**RESPONSE TO STATUTORY CONSULTEES  
HAYES PARK WEST, HAYES PARK, HILLINGDON - PLANNING REF. 12853/APP/2023/1492**

Title: Hayes Park West – Response to LB Hillingdon Comments

Title: Hayes Park West – Response to TfL Comments

**Addendum:  
response to  
Hillingdon and  
GLA comments**

## Urban Design Comments, Addendum UD6B: Proposed parking strategy for Courtyard

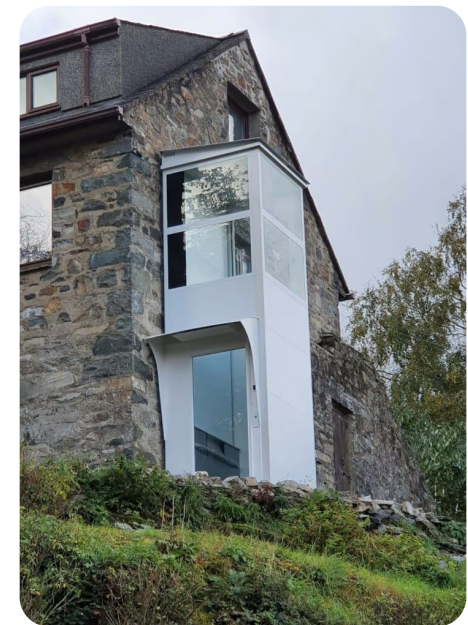
The Access Officer objects on the basis that the original submission did not include lift access and therefore did not demonstrate full compliance with London Plan Policies D5 and D7.

**A external platform lift will provided to allow level access from the front podium to the internal courtyard garden.**

Wheelchair and ambulant disabled users can call the lift at the ground floor podium and travel to the lower ground floor and access the rear courtyard via the car park. Similarly the lift can be taken from the lower ground floor (where the car park is located) up to the podium level.

The lift shall be Approved Document Part M (ADM) compliant a minimum plan area of 1100mm by 1400mm. All the controls shall be compliant with ADM.
